## **Chapter 4**

### **Comment Documents and Responses on the *Supplement***

This chapter presents scanned images or transcriptions of all oral or written comments submitted to DOE on the *Supplement*, with the DOE responses. In most instances, the response appears on the same page as the corresponding comment. Where many comments appear on a single page, however, the responses may extend to succeeding pages. The comments and responses are presented in the following order:

Fig. 5-2 Heat Generation of Spent UO<sub>2</sub> and MOX Fuel

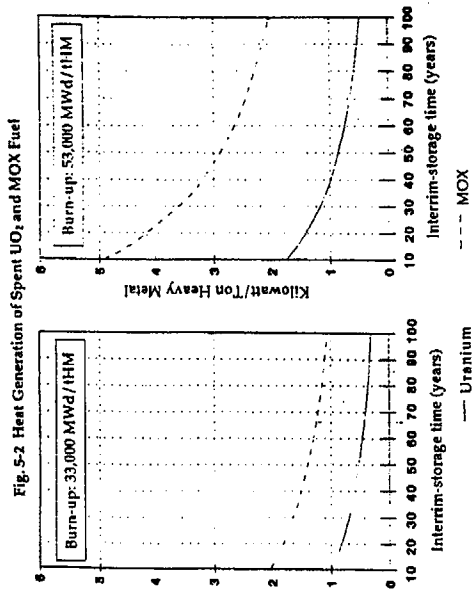
I reference the International NOK Assessment report entitled the Comprehensive Social Impact Assessment of MOX Use In Light Water Reactors by J. Takagi et al., 1997 by Pub. Citizens Nuclear Information Center, Tokyo, Japan. page 190 shows the following table for decay heat generation is presented:

Higher heat generation means MOX fuel must be stored in the cooling ponds longer and will generate more heat in a repository. I add that higher fissile material concentrations in spent MOX fuel will also be higher creating a greater criticality danger.
